# **CARIBOO GOLD PROJECT**

**PUBLIC ENGAGEMENT REPORT –  
APPLICATION REVIEW**

***November 2021***

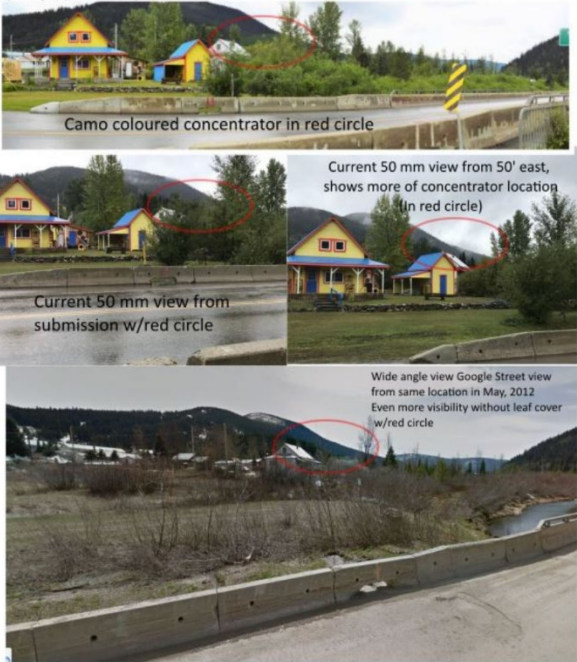
1-8	<p>Pg 8 fig 3.0-3</p> <p>Pano taken from curb level. 50' from photographers left, and from the cab height of a pickup, there is a much better picture of the concentrator, with a clear view between the tree.</p> <p>(See sample photo)</p>	<p>Visual assessment was provided for spring and summer viewing conditions when most viewers are anticipated to experience the landscape in the Visual Resources study area (e.g., recreational users and tourists). A complete Visual Assessment report will be included in the revised Application which includes analysis of seasonal effects to evaluate seasonal differences arising from the degree of vegetative screening.</p> <p>Mitigation measures to address visual effects including the colour of surface treatments to blend in with the natural surroundings will need to consider the potential seasonal variations in visual character and will need to consider the potential seasonal variations in visibility. Surface treatments have not been finalized and additional colour schemes will be assessed as required as part of the final design, however the intent is to choose a colour scheme with the least visual impact in relation to the surrounding landscape.</p>

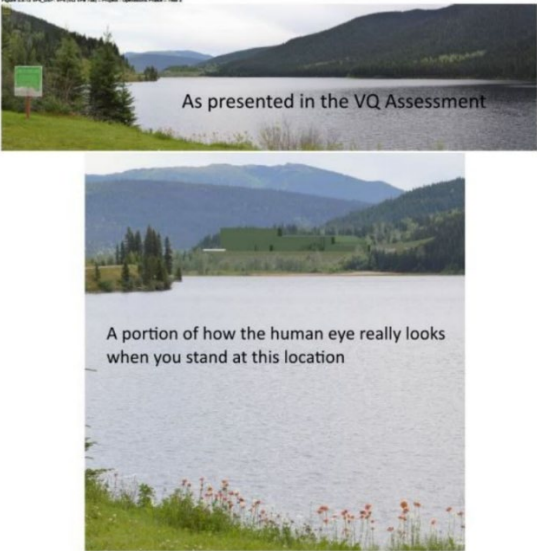
Number	Comment	Response
1-12	 <p data-bbox="226 597 953 683">Compare fig 3.0-6 with this pano photo from the same location in May. Much more of both the concentrator and the Aurum Adit are visible. Please account for this:</p>	<p data-bbox="1010 337 1793 578">The panorama provided is from Google Streetview which was captured in 2012. The images corresponds to VP3 (Burnette Ave) which was taken in 2019 and seems to show the maturation of young trees visible in the Google Streetview image and in Figure 6 of Appendix 7.11-4. There is the potential for increased seasonal visibility. Mitigation measures to address visual effects are identified in the Application including revegetation to blend in with the natural surroundings and will need to consider the potential seasonal variations in visual character and visibility.</p>
1-13	<p data-bbox="226 735 323 797">Page 14 fig 3.0-12</p> <p data-bbox="226 805 953 954">This is a perfect example of the inadequacy of VQ data. Although the wide angle shot accurately depicts the size of the building, the photo doesn't account for the human eyes ability to focus on the anomaly . (Note, for instance, the effect of the sign on the viewer...even in the submission.)</p>	<p data-bbox="1010 735 1793 914">The horizontal extent of panoramic images in Appendix 7.11-4 depicts the landscape context visible to viewers from key viewpoints. As indicated in Appendix 7.11-4, all photos were cropped to a width that represents the field of view which an observer can view in a single viewing direction (a horizontal viewing angle of between 100° and 120°) based on established visual simulations guidelines.</p>

Number	Comment	Response
	 <p data-bbox="378 844 840 876">Figure 1: Mine/Camp and Septic Field (Square)</p>  <p data-bbox="378 1388 840 1421">Figure 2: Google earth image of wetland at Septic</p>

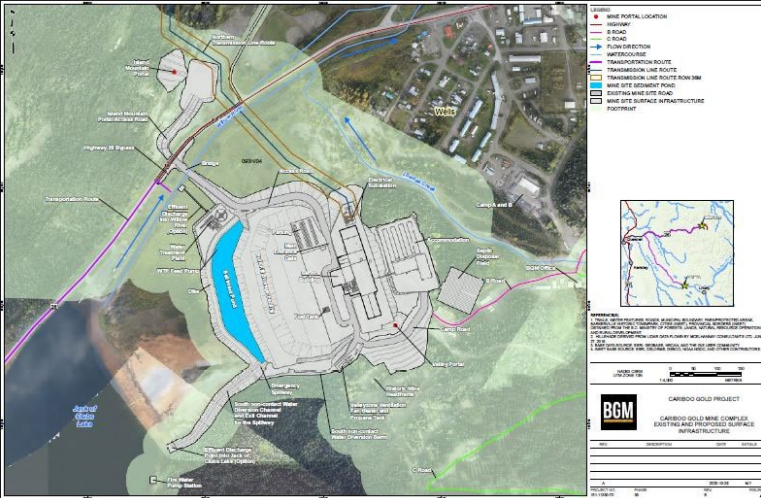
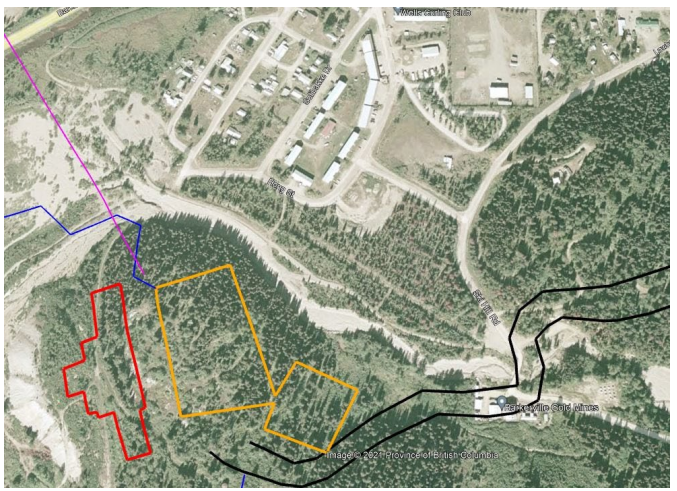
Number	Comment	Response
13-1	<p>Sewage treatment for the Mine Camp: The Proposal for the mine includes a holding tank and 700 m septic field for the residential camp, that will conform to the Municipal Waste Water Regulation.</p> <p>I have some concerns about the location and size of this facility. A 200 man camp will effectively represent the waste production of the entire community of Wells. The proposal to locate the sewage treatment at the site indicated on the map raises some questions.</p> <p>Presumably a perk test has been done at this site? Currently, it is a low wet bog, at the confluence of three surface and subsurface streams from the mountainside. These streams have a diffuse discharge along the south side of Lowhee Creek, just a few metres from the end of the septic field. As well, Lowhee Creek exhibits some ongoing erosive effects along that section of unprotected bank.</p>	<p>The treatment system for the camp consists of a moving bed bioreactor which provides secondary-level of treatment (i.e., biological reduction in organic matter) before the treated effluent will be discharged to the drainage galleries of the septic field. The septic field was sized to meet the requirements of the Municipal Wastewater Regulation (MWR) for a percolation rate of 15 minutes/25 mm, which takes into consideration the permeability of the soils into which the septic field will drain. The MWR also requires a minimum setback distance of 30 m from water bodies to minimize the potential for the treated effluent to affect surfacewater bodies.</p>

13-2	<p>The District of Wells is in an ongoing flood protection 'dispute' with provincial authorities regarding the armouring of Lowhee Creek. I am concerned that adding the water discharge from a 200 man camp to the already saturated ground in the proposed location may result in additional soil instability which may cause environmental damage or increase the liability of the city or the province regarding stream protection in municipal boundaries. In addition, a significant flood event in the creek could threaten the entire septic system with damage or destruction. Finally, given the ongoing wet draining effect of the existing groundwater, and the short distance to the creek, I am concerned that there may be leaching of bacterial loads into Lowhee Creek above a community recreational swimming area(at the 'Y', or even compromise the community discharge readings from stream flow samples below the community water treatment center.</p>	<p>The septic field was sized to meet the requirements of the Municipal Wastewater Regulation for a percolation rate of 15 minutes/25 mm, which takes into consideration the permeability of the soils into which the septic field will drain. The percolation rate is intended to maintain a minimum depth of unsaturated soil below the septic field (0.75 to 1 m for the quality of effluent that the MBBR will produce). The MWR also requires a minimum setback distance of 30 m from water bodies to minimize the potential for the treated effluent to affect surfacewater bodies.</p>

Page 14  
fig 3.0-12

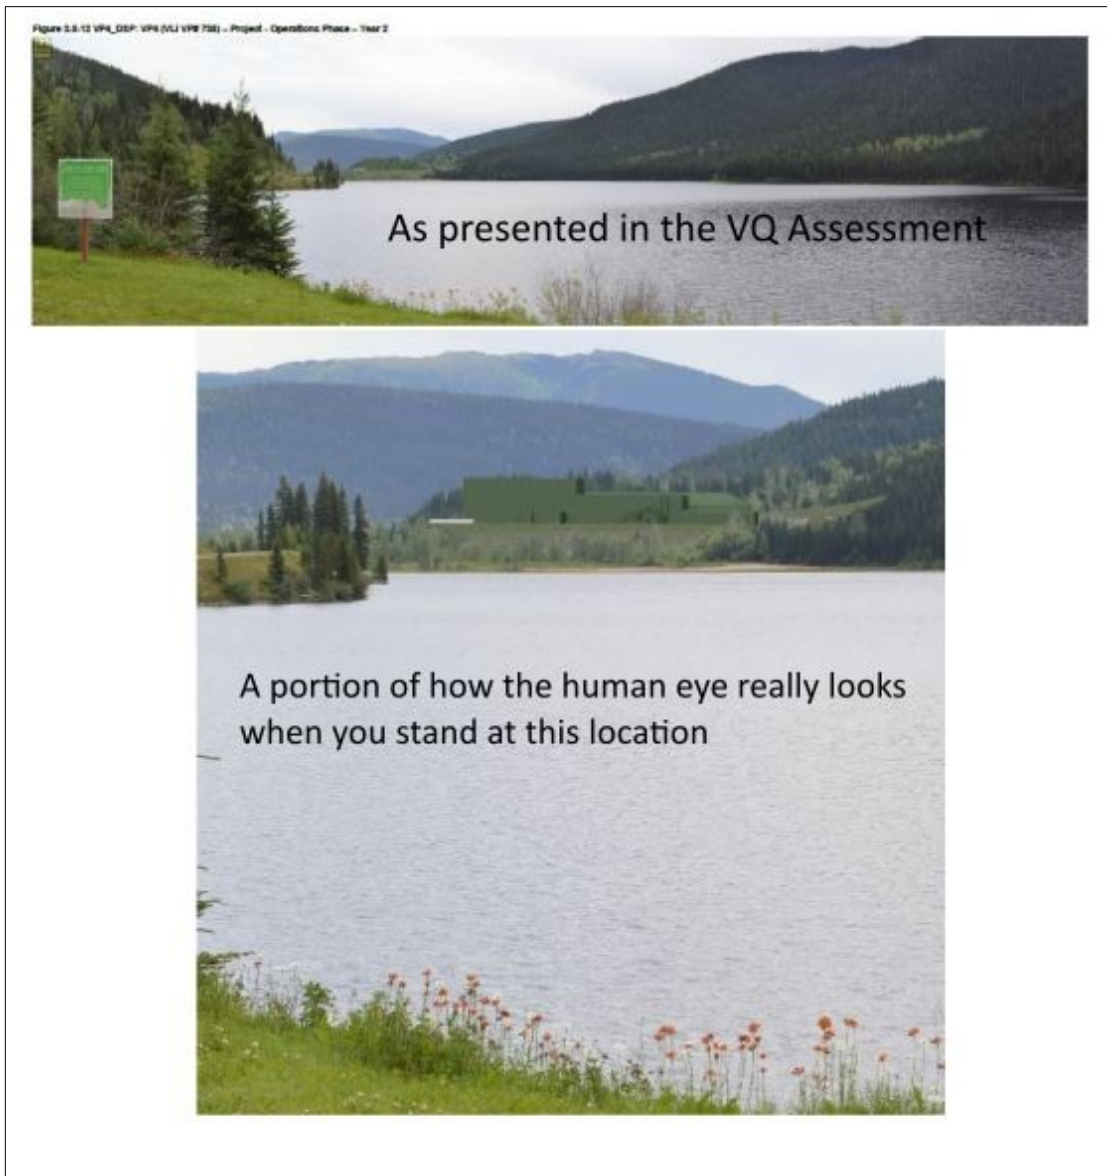
This is a perfect example of the inadequacy of VQ data. Although the wide angle shot accurately depicts the size of the building, the photo doesn't account for the human eyes ability to focus on the anomaly. (Note, for instance, the effect of the sign on the viewer...even in the submission.)

Human Activity, emissions, dust, also not accounted for  
 Winter simulations building colour will stand out against white landscape.  
 Please indicate how you will mitigate these issues.

Figure 1: #3 VQ Station. Pooley street from Google earth

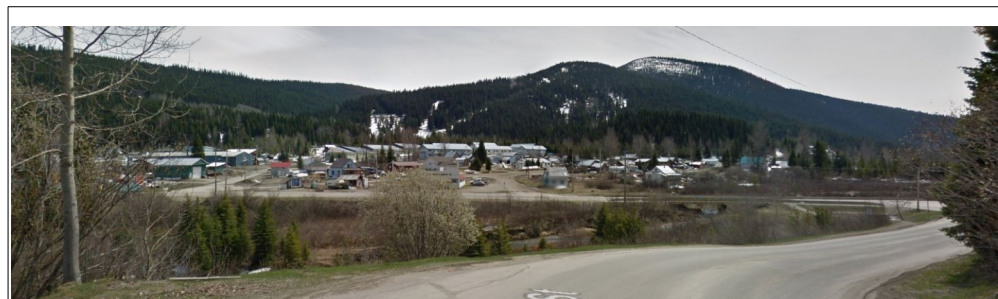
A third location should be done from East Pooley Street in front of the old Jack O Clubs Hotel

Number	Comment	Response
	<p data-bbox="226 337 961 391">A third location should be done from East Pooley Street in front of the old Jack O Clubs Hotel.</p> 	<p data-bbox="1012 337 1787 513">Although there are numerous locations across the landscape where the Project may be visible, the key viewpoints selected for the visual assessment aim to provide a representative sample to understand the potential visual effects of the Project from a variety of viewing angles and distances, and types of land use sites (e.g., residents, roads, recreation sites, etc.).</p> <p data-bbox="1012 558 1734 670">The selection of viewpoints was based on established viewpoint identification criteria (see Section 7.11 Land and Resource Use Sec. 7.11.3.3.3 and Appendix 7.11-2) and best practices. This includes viewpoints that provided the least obstructed views where possible.</p>

Figure 1: Mine/Camp and Septic Field (Square) *Figure 2: Google earth image of wetland at Septic site.*

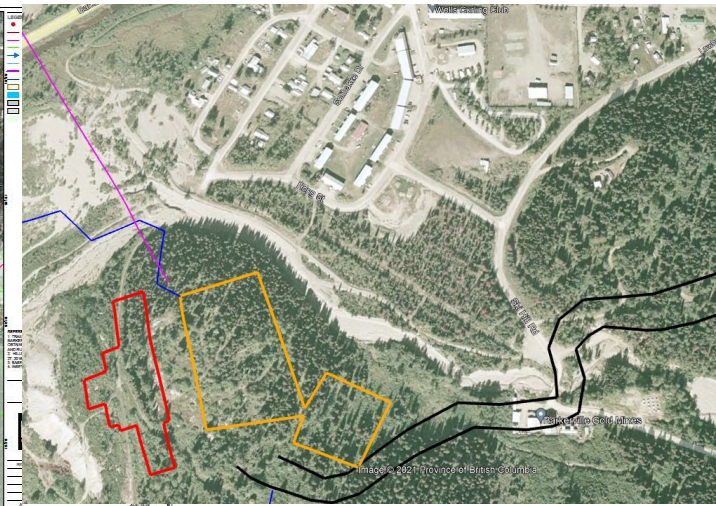
Presumably a perk test has been done at this site? Currently, it is a low wet bog, at the confluence of three surface and subsurface streams from the mountainside. These streams have a diffuse discharge along the south side of Lowhee Creek, just a few metres from the end of the septic field. As well, Lowhee Creek exhibits some ongoing erosive effects along that section of unprotected bank.

The District of Wells is in an ongoing flood protection 'dispute' with provincial authorities regarding the armouring of Lowhee Creek. I am concerned that adding the water discharge from a 200 man camp to the already saturated ground in the proposed location may result in additional soil instability which may cause environmental damage or increase the liability of the city or the province regarding stream protection in municipal boundaries. In addition, a significant flood event in the creek could threaten the entire septic system with damage or destruction. Finally, given the ongoing wet draining effect of the existing groundwater, and the short distance to the creek, I am concerned that there may be leaching of bacterial loads into Lowhee Creek above a community recreational swimming area (at the 'Y', or even compromise the community discharge readings from stream flow samples below the community water treatment center.

What assurances does Osisko have that this site is appropriate for the intended use?
